VILLAGE BOARD OF TRUSTEES MEETING

MONDAY, DECEMBER 4, 2023 AT 6:00 PM

Subject: Williams Bay – Women’s Leadership Center Site Plan Approval Recommendation

To: Plan Commission – Village of Williams Bay
From: Attorney Mark A. Schroeder
Date: November 6, 2023
Re: Constance Woods LLC Development Proposal

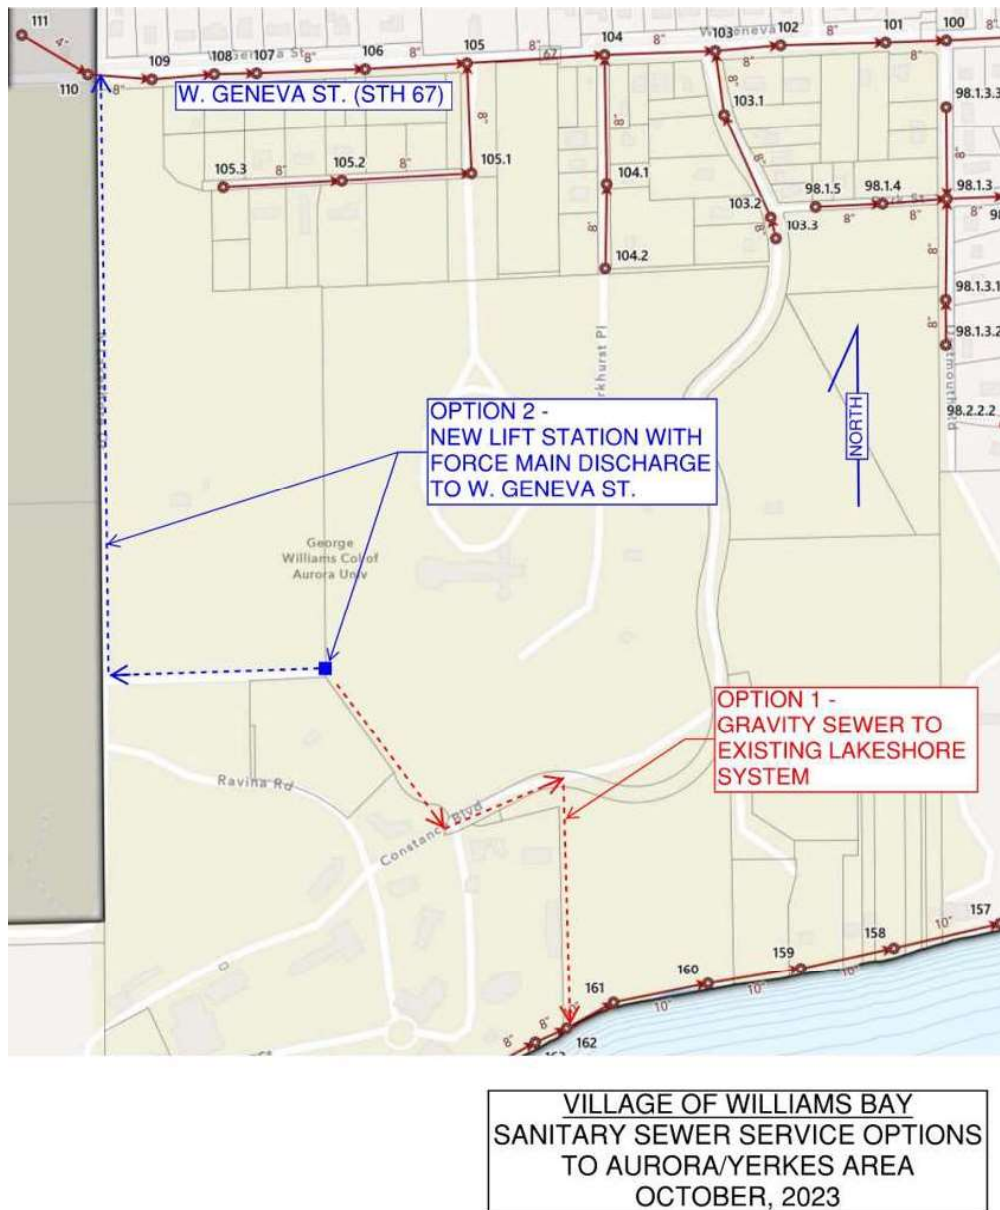
Water Main: See reference 1 and 2 on the attached site plan. There is an existing 6-inch water main and easement traversing the property within the footprint of the proposed building and parking lots. The plan is to abandon the water main and vacate the water main easement and allow a new 8-inch water main within a 20-foot-wide easement as a replacement. The new route would follow the private roadways and make a connection to the right of way of Constance Boulevard. We would recommend approval of this portion of the site plan and need committee concurrence.

Sanitary Sewer Paralleling the Lakefront: See Reference 3 on the attached site plan. There is an existing 10-inch gravity sanitary sewer that extends from Lift Station 5 in Conference Point that is within a 10-foot easement. This sewer was televised shortly after the WLC project began; the televising found significant grease, debris, and clear water inflow. This downstream sewer needs cleaning and repair to provide adequate service to WLC and George Williams. WLC has refused to participate in the funding of this repair, even though they are a new connection to the sewer. They appear willing to vacate the existing 10-foot-wide sanitary sewer and provide a 20-foot-wide replacement easement. We recommend approval of this portion of the plan if the Village commits to the sewer cleaning and repair prior to occupancy. We need input from committees on how to proceed with this issue.

Existing Drainage and Future Reconstruction of Constance Boulevard: See Reference 4 and 5 on the attached site plan.

- Regarding Reference 4: WLC is proposing to locate a dock and boardwalk in an existing drainage ravine that drains Constance Boulevard and areas upstream. We are requiring that they provide the proper hydraulic calculations to show the 100-year flood boundary on their property with the proposed structures and the existing trees. We recommend a storm sewer easement that includes this 100-year flood boundary. This will allow the Village to reconstruct Constance Boulevard without claims and prevent future owners from adding more structures to the flood boundary. WLC is resisting this; we need input from committees on how to proceed with this issue.

Sanitary Sewer Easement – West Property Line: See Reference 6 on the attached site plan and the snip below.

- This proposed 20-ft minimum exclusive easement for sanitary sewer near the west property line may prevent the Village from spending an additional \$2 million for a sewage lift station and force main connection to W. Geneva Street to provide sanitary sewer service to the areas north and west of this property.
- The Village can vacate this requested easement in the future if they decide to leave this area unsewered or find alternate means of providing sanitary sewer service to the area upstream.
- It is unlikely that the requested easement can be obtained by eminent domain in the future since there is another option available.

C-500 Page 104 of 198

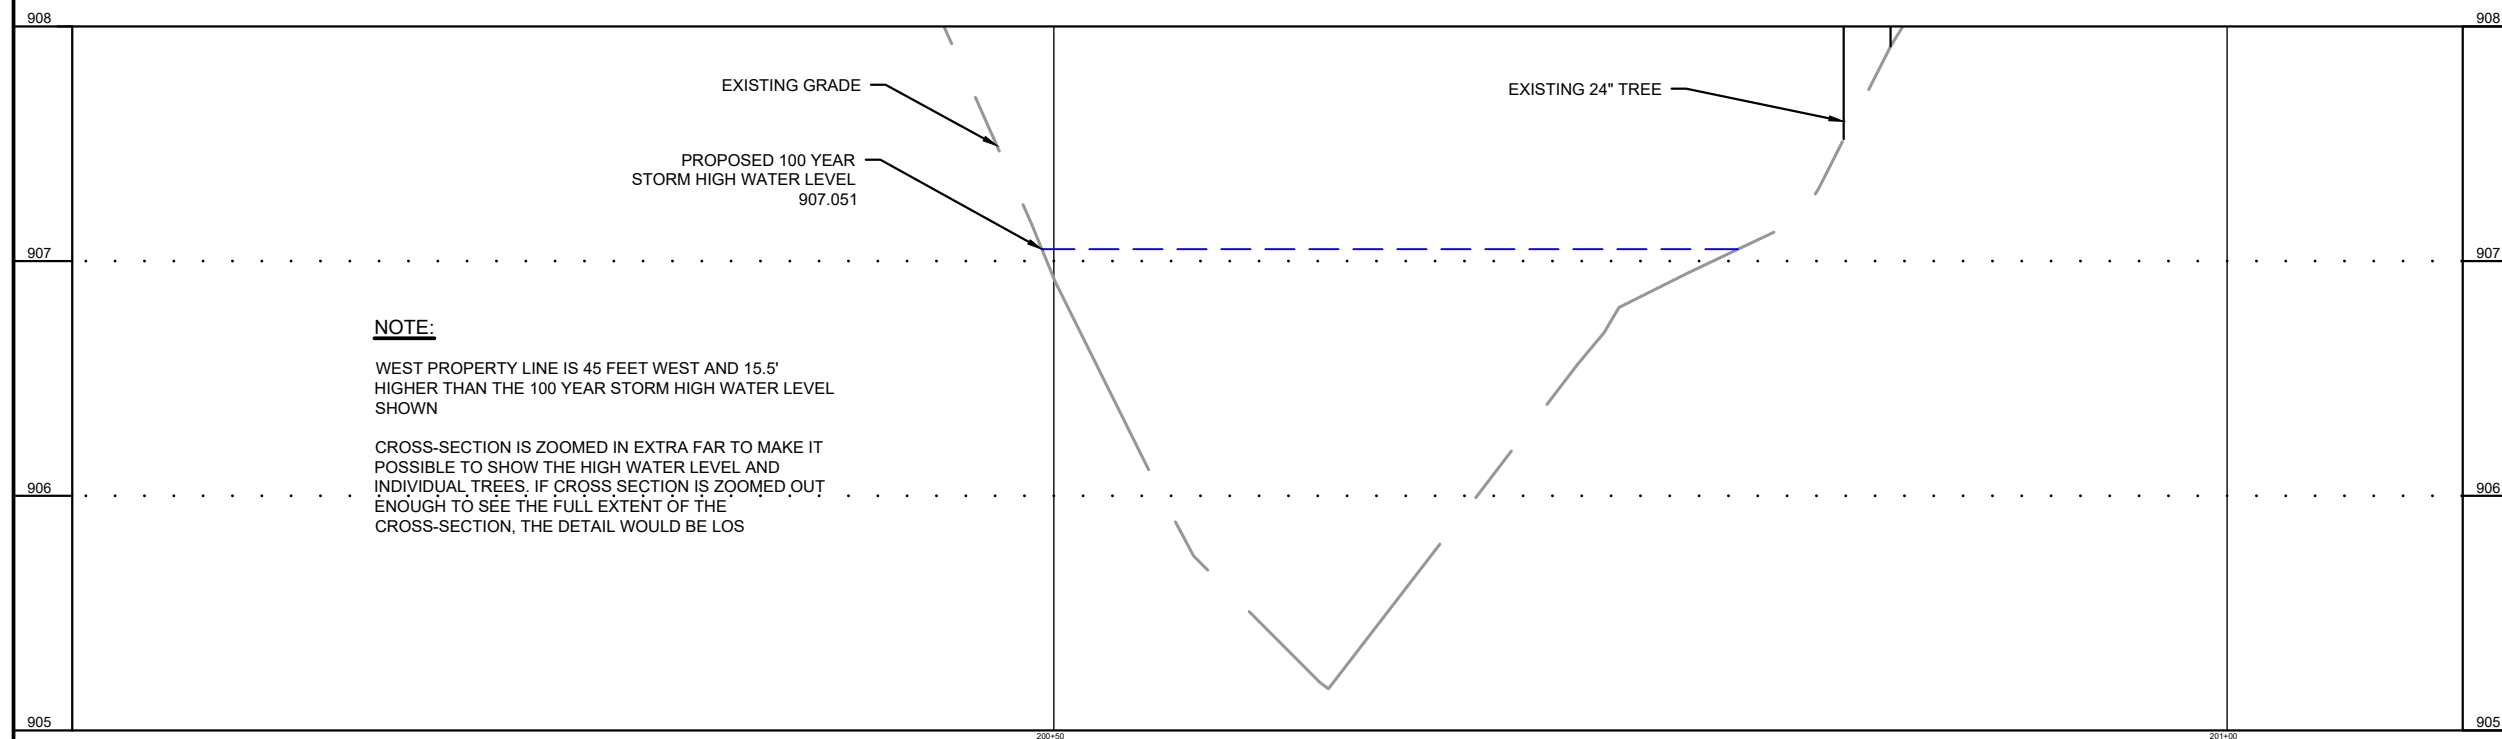
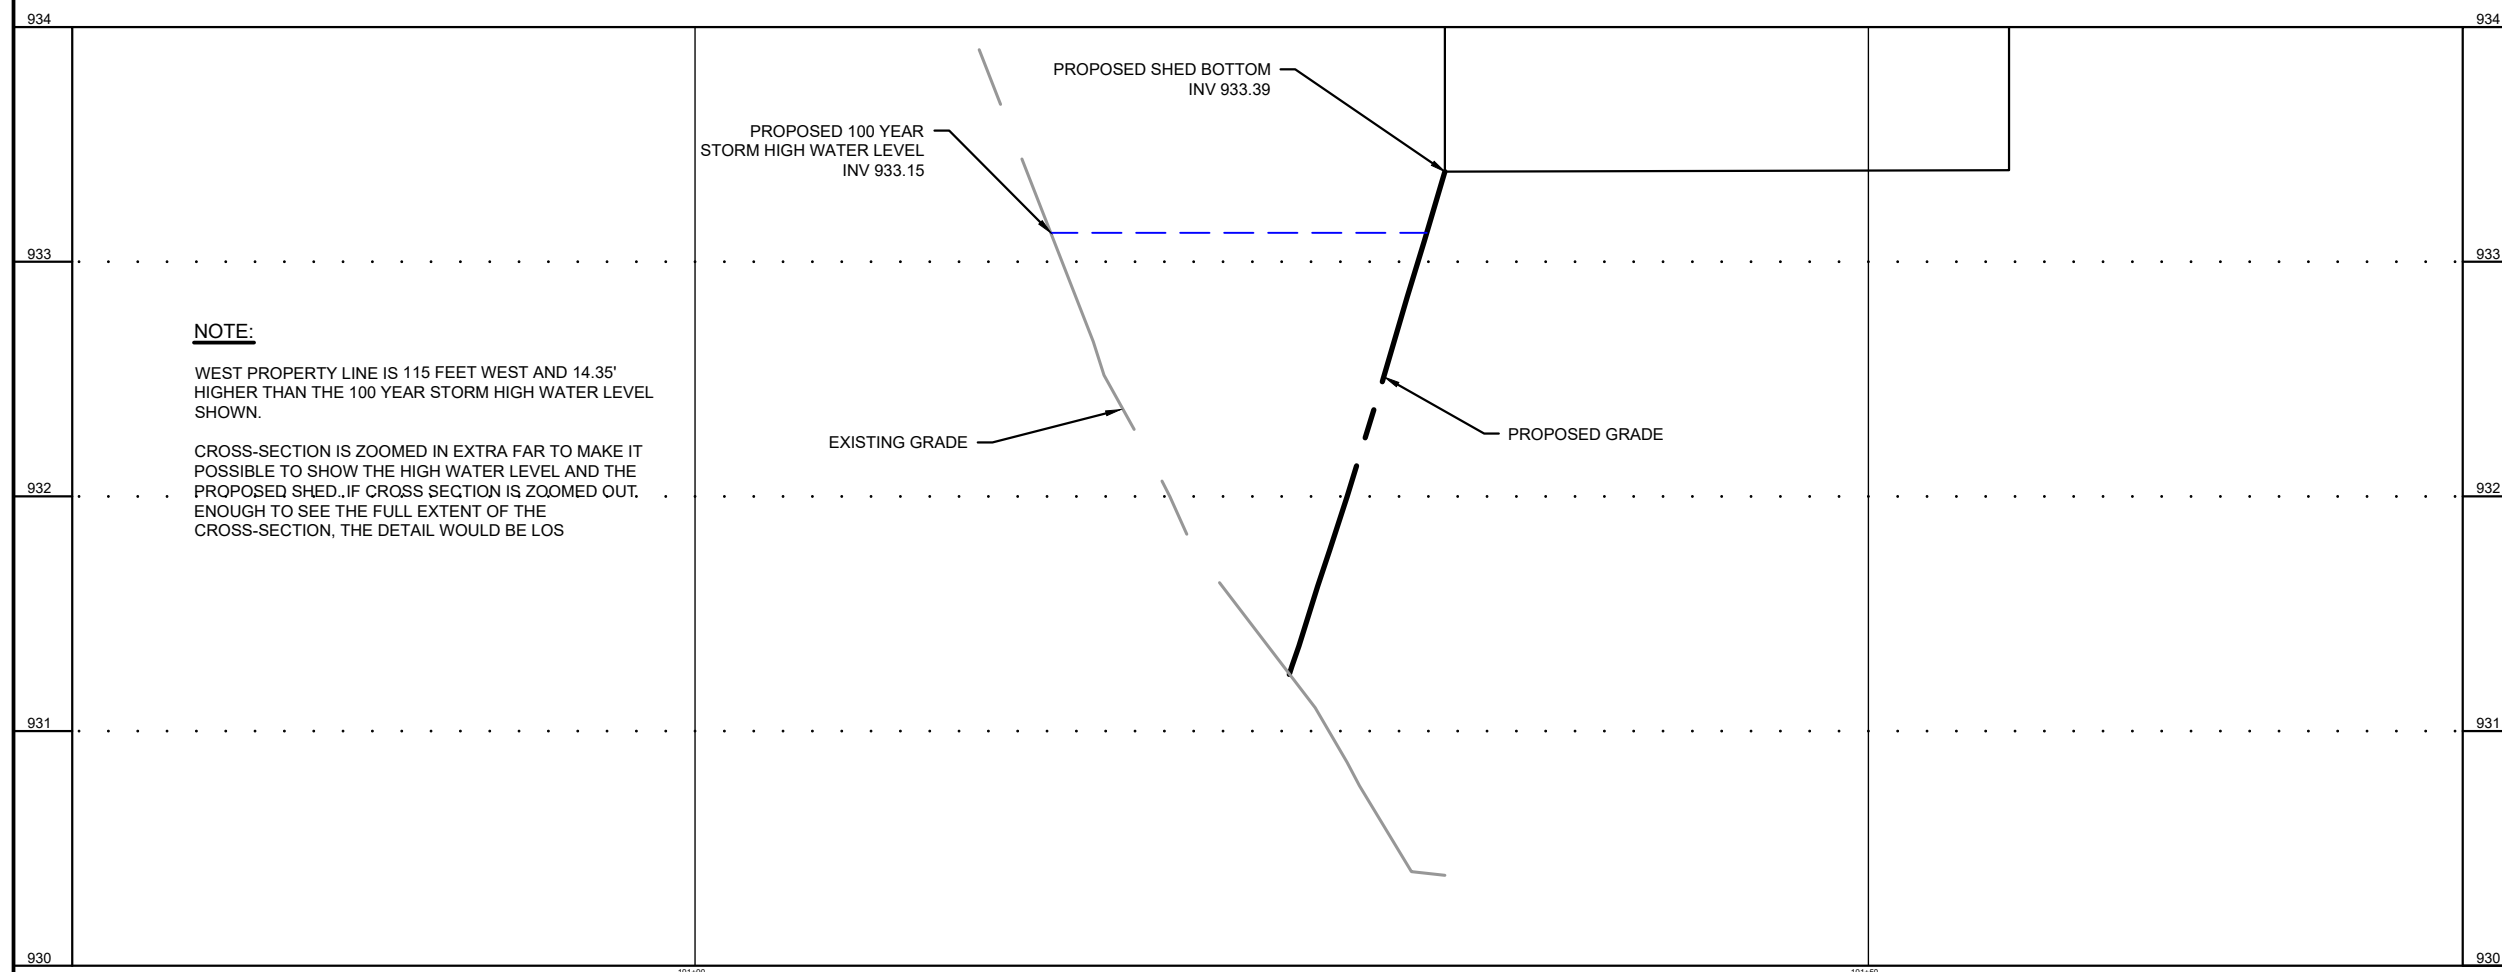
1. Sheet C-500 (Grading & Erosion Control Plan): We normally do not allow new structures in the 100-year overland flow route. Please show the following to confirm the new structures will not cause onsite or offsite issues:

- a. Tie the location of the analyzed cross-sections to the property lines. They are not shown on Exhibit 2 as noted in the response letter.

Exhibit 2 of the Storm Water Management Report (pg. 15) has been updated to show the 100-year overland flow route boundary. Additionally, sheets have been added to Appendix E (pgs. 225-229) to show the four cross-sections referenced in Exhibit 2 with existing trees and proposed boardwalk pilings. These documents are included with this letter for reference. A Manning roughness coefficient (n) of 0.15 was used in our channel analysis, which is a typical n-value for medium dense brush and dense willows in natural stream channels.

Exhibit 2 (pg. 15 of the SWMR and included with this letter) has been updated to show the four analyzed cross-sections (A-A, B-B, C-C and D-D).

Sheets added to Appendix E (pgs. 225-229) and included in this letter to show the four cross-sections referenced in Exhibit 2 with existing trees and proposed boardwalk pilings. The 100-year overland flow boundary was also drawn and added to Exhibit 2. The n-value of the cross-section model is approximately double what it should be ($n=0.15$ is equivalent to dense brush with many downed trees). This provides an extremely conservative estimate and that is what is shown in Appendix E and Exhibit 2. Please note, the scaling on the cross-section views are very different in the model versus the sheets added to Appendix E with the trees and boardwalk shown.
